**TO:** T10 Membership  
**FROM:** Paul A. Suhler, Certance  
**DATE:** 24 October 2003  
**SUBJECT:** T10/03-367r0, ADT Annex: Error detection and recovery action examples

**Error detection and recovery action examples****A.1 Introduction**

**Figure A.1 – Receiver-Detected Error**

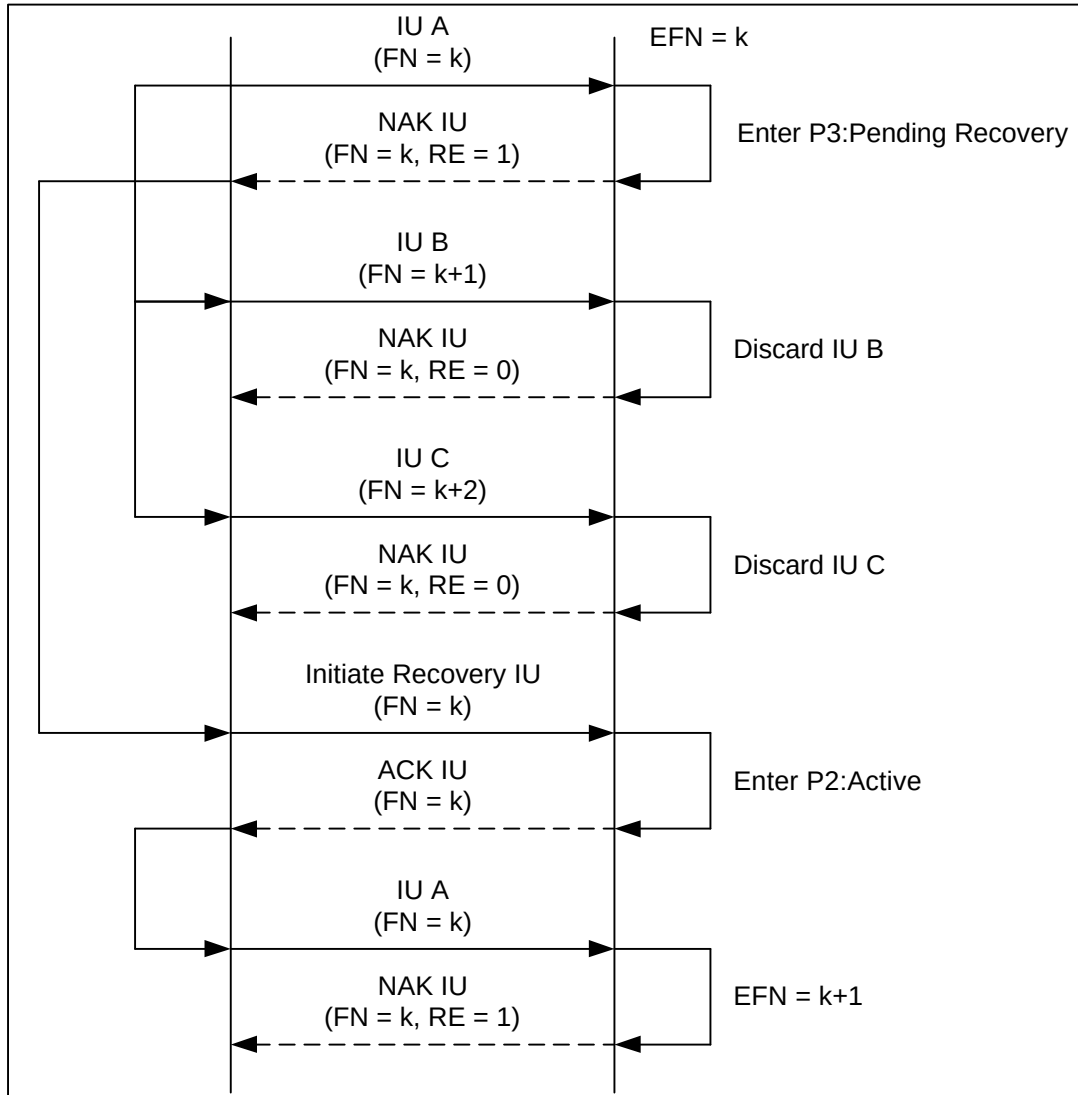
**Note:** ACK Offset > 1 allows IU B to be sent immediately after IU A.

### Figure A.2 – Lost ACK IU

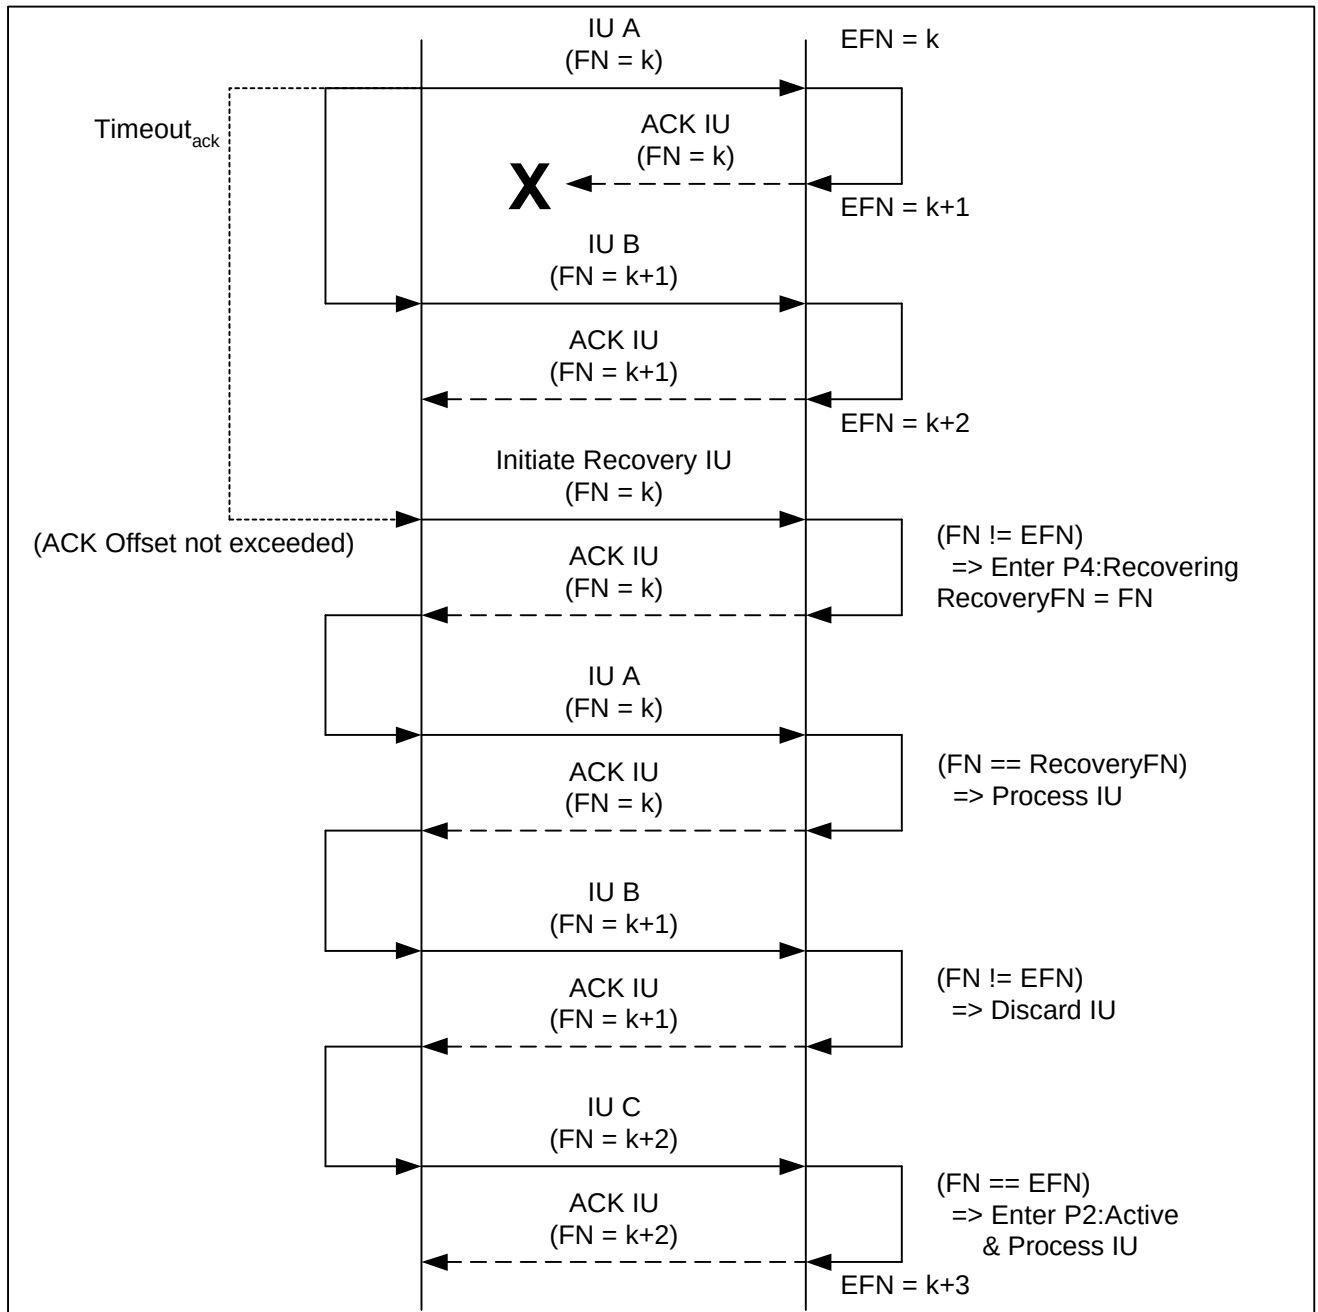
**Note:** ACK Offset > 1 allows IU B to be sent immediately after IU A.

**Figure A.3 – Lost IU**

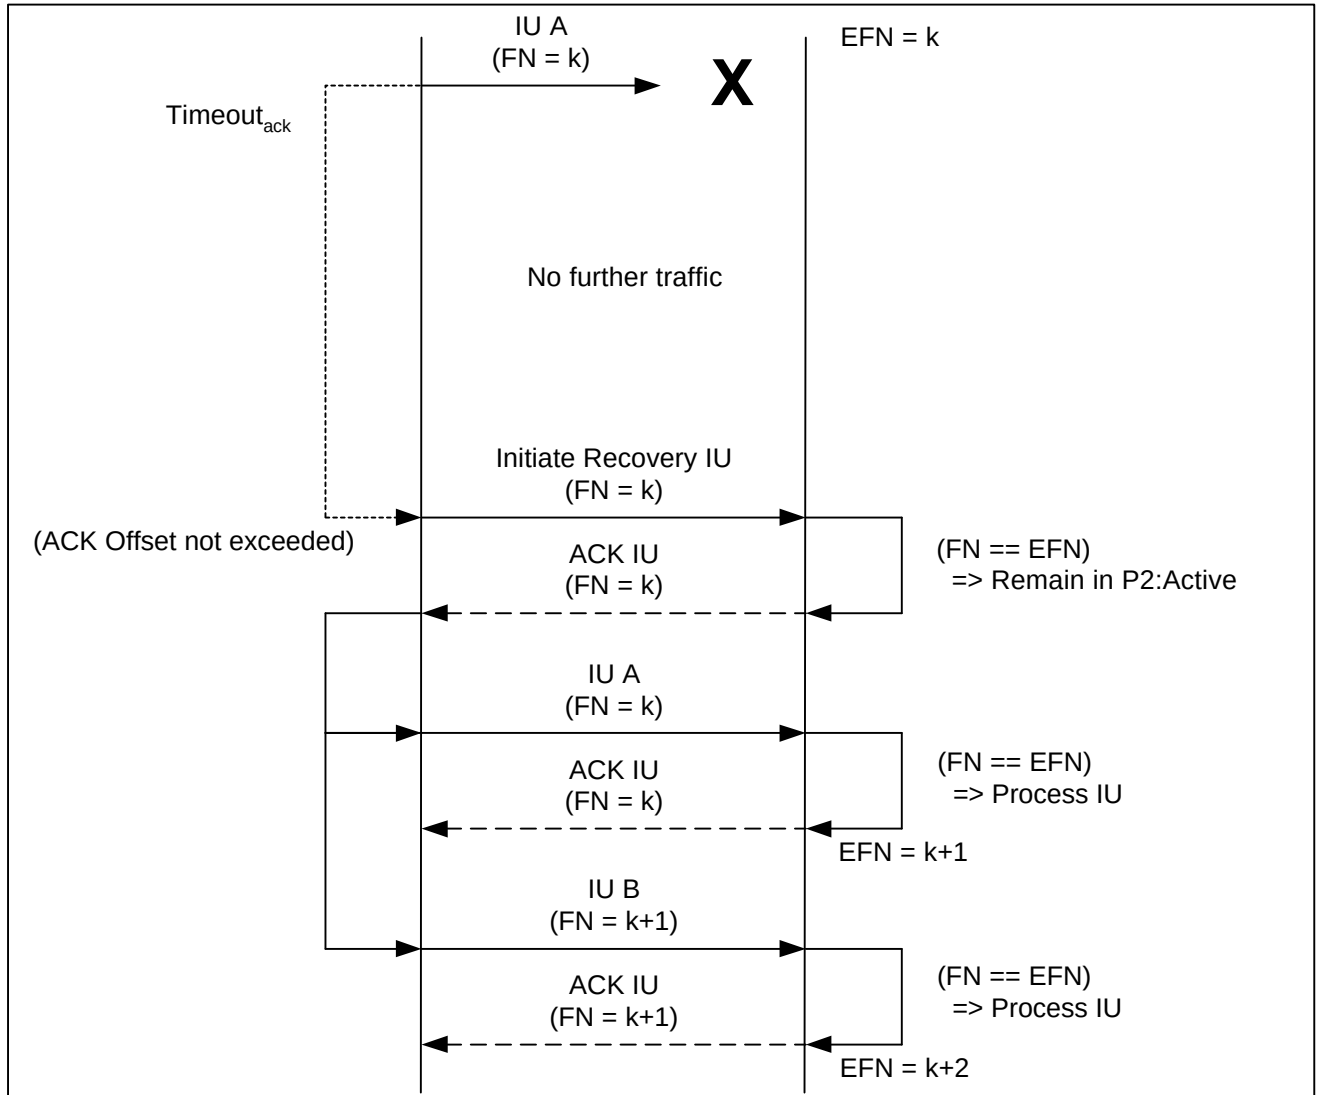
**Note:** After retransmission of IU A, ACK Offset > 1 allows IU B to be sent immediately.
